## THE CITY OF KEY WEST

## ADDENDUM NO. 2 – AQUARIUM SEAWALL REPAIR ITB 18-036

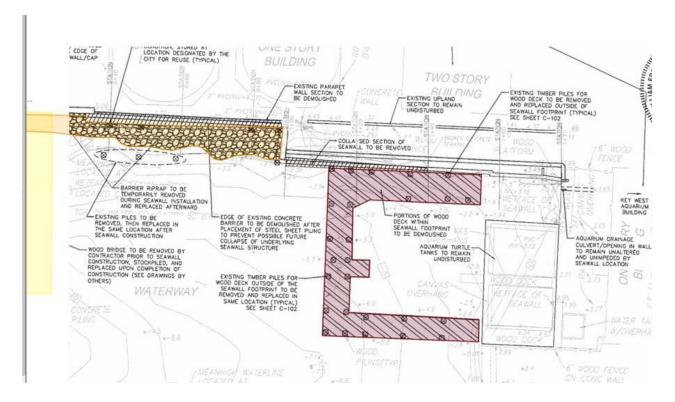
2. In page C-101 the existing wood deck (shown in red below) call to be removed and stockpiled during construction and replaced. The construction plans do not show any details in how and what kind of materials should be replaced.

Remove only wood decking and pilings required for wall installation. Bidder will not be required to replace any decking. All pilings removed will be required to be replaced per the plans.
